Requesting Engineer: Selda Heavner

### STEREO IMPACT PLASTIC LVPS FM1 REWORK INSTRUCTIONS

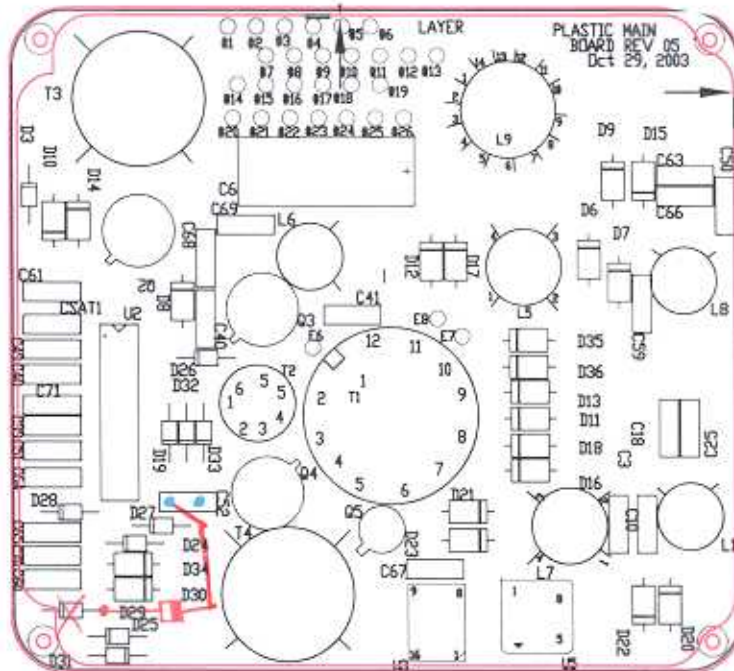
- 1) D29 Cathode is touching the Plastic LVC Box.

**Solution:** Remove D29. Use a new part JANTXV1N5711-1. D29 can be soldered on the bottom side of the Plastic Main board and the cathode of D29 will be soldered on directly to C52. The leads of new D29 should have shrink tubing. Epoxy the pad (D29 cathode that is not used) that is exposed.

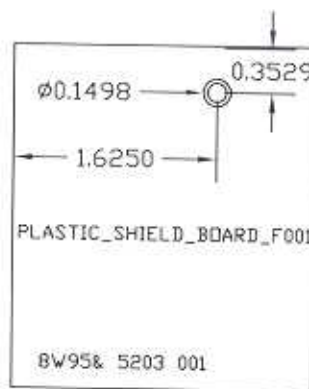
- 3) Drill a hole on Plastic LVC Input Shield Board at dimensions shown below. The input power wires shall go through this hole. Use green epoxy after the hole is drilled. (The wires must be twisted). All dimensions shown in the figure are in inches.
